Notice of Allowability

09/828,202

SHIEH, JIA-HORNG

FIG. 1
(RELATED ART)

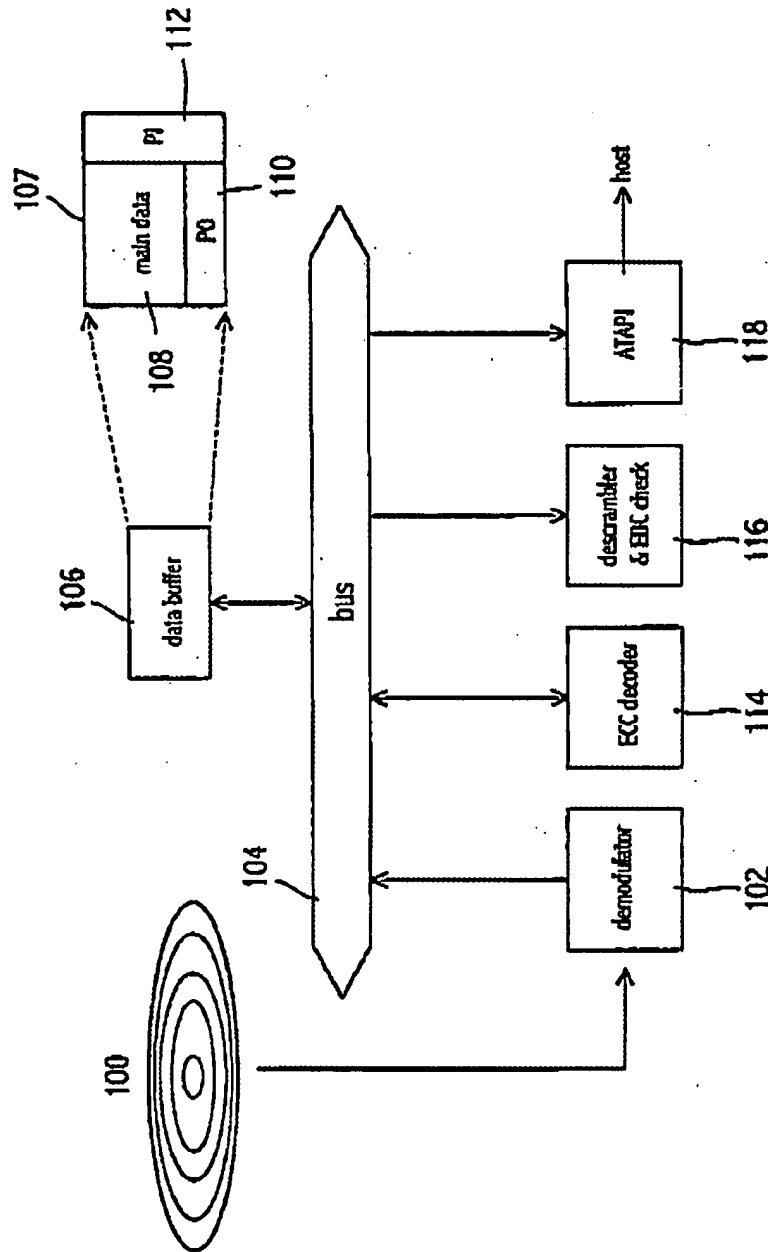
Applicant's submitted prior art's figure 1 disclosed a conventional decoding system in a DVD storage system includes, a demodulator (see element 102) reads data and the data stored in the disk (see element 100) whereby the demodulator generates an ECC block (see element 107) and transmits to a data buffer (see element 106) wherein the ECC block comprises main data, PI (parity inner code), PO (parity outer code). Further, the prior art of record, Iwasa (U.S. PN: 6,470,473) disclose a DVD data decoding processing system (see figure 3, reference number 30) includes a DVD reproducing unit (see element 32) and a buffer memory (see element 34) whereby the DVD reproducing unit includes a demodulating unit (see element 36) coupled to a PI syndrome generating unit (see element 38), an error correcting unit (see element 40), a PI syndrome storing memory (see element 48), a buffer memory (see element 42) having a memory capacity corresponding to a few lines, a PO syndrome generating unit (see element 44), a de-scrambling/EDC calculating part (see element 46), a PO syndrome storing memory (see element 50), an EDC calculation result storing memory (see element 52) and an error correcting part (see element 54), which are coupled as shown. However, the prior art taken singly or in combination fail to teach, anticipate, suggest, or render obvious a syndrome generator for generating a PI (Parity of Inner-code) direction syndrome and a PO (Parity of Outer-code) direction syndrome from an ECC (Error Correction Code) block comprising a main data, a PI, and a PO; a memory that stores said PO direction syndrome during generation of said PO direction syndrome; a data buffer for storing said main data from said ECC block, said PI direction syndrome and said PO direction syndrome; and an ECC decoder for performing error correction decoding of said main data stored in said data buffer, using said PI direction syndrome and said PO direction syndrome. Consequently, claim 1 is allowed over the prior art.

Applicant's submitted prior art's figure 1 disclosed a conventional decoding system in a DVD storage system includes, a demodulator (see element 102) reads data and the data stored in the disk (see element 100) whereby the demodulator generates an ECC block (see element 107) and transmits to a data buffer (see element 106) wherein the ECC block comprises main data, PI (parity inner code), PO (parity outer code). Further, the prior art of record, Iwasa (U.S. PN: 6,470,473) disclose a DVD data decoding processing system (see figure 3, reference number 30) includes a DVD reproducing unit (see element 32) and a buffer memory (see element 34) whereby the DVD reproducing unit includes a demodulating unit (see element 36) coupled to a PI syndrome generating unit (see element 38), an error correcting unit (see element 40), a PI syndrome storing memory (see element 48), a buffer memory (see element 42) having a memory capacity corresponding to a few lines, a PO syndrome generating unit (see element 44), a de-scrambling/EDC calculating part (see element 46), a PO syndrome storing memory (see element 50), an EDC calculation result storing memory (see element 52) and an error correcting part (see element 54), which are coupled as shown. However, the prior art taken singly or in combination fail to teach, anticipate, suggest, or render obvious a syndrome generator for generating a PI

Applicant's submitted prior art's figure 1 disclosed a conventional decoding system in a DVD storage system includes, a demodulator (see element 102) reads data and the data stored in the disk (see element 100) whereby the demodulator generates an ECC block (see element 107) and transmits to a data buffer (see element 106) wherein the ECC block comprises main data, PI (parity inner code), PO (parity outer code). Further, the prior art of record, Iwasa (U.S. PN: 6,470,473) disclose a DVD data decoding processing system (see figure 3, reference number 30) includes a DVD reproducing unit (see element 32) and a buffer memory (see element 34) whereby the DVD reproducing unit includes a demodulating unit (see element 36) coupled to a PI syndrome generating unit (see element 38), an error correcting unit (see element 40), a PI syndrome storing memory (see element 48), a buffer memory (see element 42) having a memory capacity corresponding to a few lines, a PO syndrome generating unit (see element 44), a de-scrambling/EDC calculating part (see element 46), a PO syndrome storing memory (see element 50), an EDC calculation result storing memory (see element 52) and an error correcting part (see element 54), which are coupled as shown. However, the prior art taken singly or in combination
